independent assessment of development application no. 172/2016

**Construction of an Eight (8) Storey Residential Flat Building,
Child Care Centre and
Neighbourhood Shop**

**Lots 101 and 102 DP 1013285
and Lot 31 DP 540796
Nos. 296-314 Burns Bay Road,
Lane Cove**

**REPORT TO JRPP – DA 172/16
296 – 314 BURNS BAY RD, LANE COVE**

Figure 7 – Section showing location and extent of encroachment of roof profile

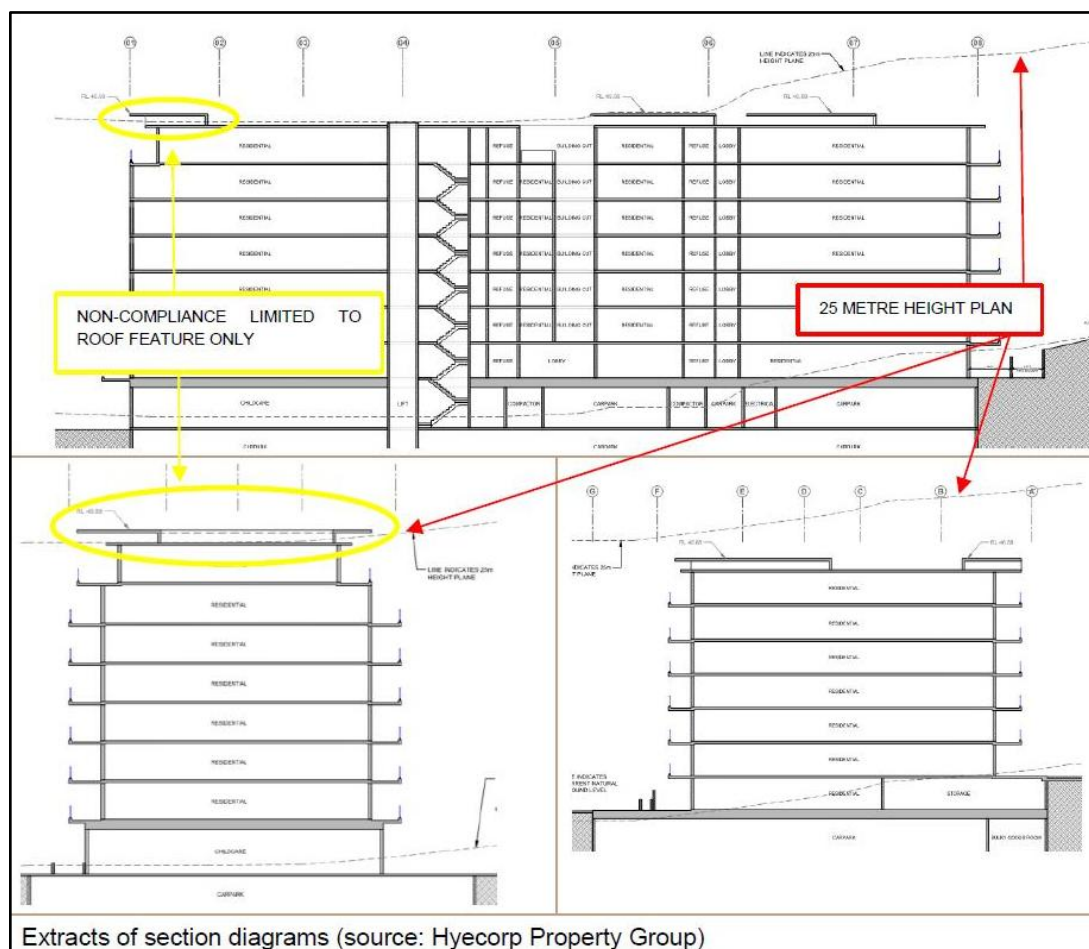
The majority of the development falls within the 25.0 metre height plane, with the exception of a minor portion of the roof along the southern side of the building, which has a maximum height of 25.950 metres, which exceeds the height limit by 950mm. The location of this encroachment is shown on Figure 6 below and Figure 7 on the following page.

The applicant has indicated that the proposed encroachment of the height limit can be approved using Clause 5.6 – architectural roof features, which allows consent to be granted to development that exceeds, or causes a building to exceed, the height limits set by clause 4.3. In this regard, Clause 5.6(3) states that:

This issue has been discussed with Council's SEPP 65 Officer, who has advised that the section of roof that encroaches the 25 metre height limit is indeed a specific feature or separate, decorative element (as opposed to part of the roof proper) and therefore is a feature for which Clause 5.6 is specifically set up to permit. In this regard, the feature in question comprises an additional element above the actual roof (as shown by Figure 7), which is located immediately beneath and which is in fact below the 25 metre height restriction as required to be. Furthermore, Council's SEPP 65 Officer has indicated that the roof feature satisfactorily meets each of the objectives identified under Clause 5.6 as indicated by the applicant and, which as a result, provides for a more articulated roof form and improved built form outcome. As such, it is considered that Clause 5.6 is an appropriate mechanism to permit the minor encroachment to the roof feature in this instance and it is therefore recommended that it be permitted on this basis.
